SUBJECT: Terry Miller Building Windows & Siding Change Order 5

# CHANGE ORDER

Project (ITB or RFP) No.: 625 Change Order No.: 05

Project (ITB or RFP) Title: Terry Miller Legislative Office Building Window and Exterior Renovation

RFP 007 Construction Images:

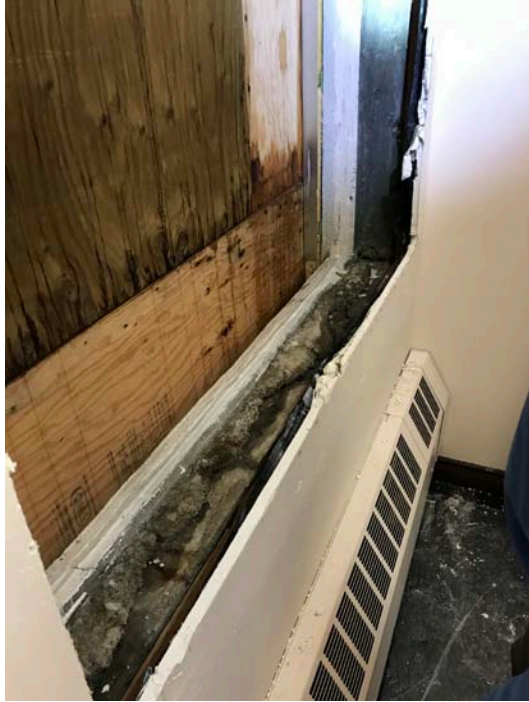
View of typical West addition sills along Main Street. Sills require grouting to fill voids for proper window receiver shimming and form smooth transition to support scheduled exterior sill flashing.

View of typical window sill in Library. Sills require grouting to fill voids for proper window receiver shimming and form smooth transition to support scheduled exterior and interior sill and flashing.

View of typical north and south window sills under abated wood window bucks that became the wood grounds for original wood window rough opening. Sills are heavily impacted by air pockets, unconsolidated concrete and concave voids. Sills throughout the 1927 and 1961 work require grouting to fill voids for proper window receiver shimming and form smooth transition to support scheduled exterior and interior sill and flashing.

View of typical north and south window sills under abated wood window bucks. This condition of unconsolidated concrete under the window bucks (wood grounds) is present at all floors and window openings that have been demolished.

TMB Legislative Office Bldg Window and Exterior Reno  
North and West Wall - Window Wood Grounds at Jambes and Grout at Sill

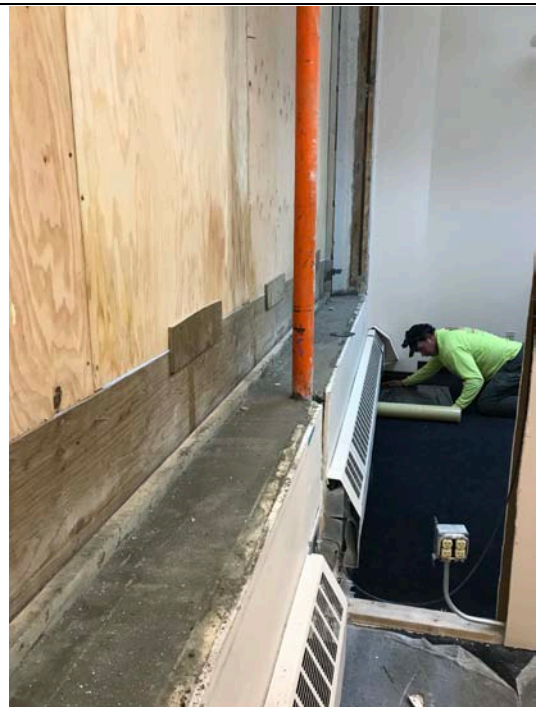
View of the typical window head encountered along the third floor of the 1927 structure. The concrete that was placed at the window bucks and appears to not have consolidated around the lower rebar. The condition of the heads varies due to the size of the aggregate used during this time.

View of typical window head repair anchored into concrete at window heads and jambs.
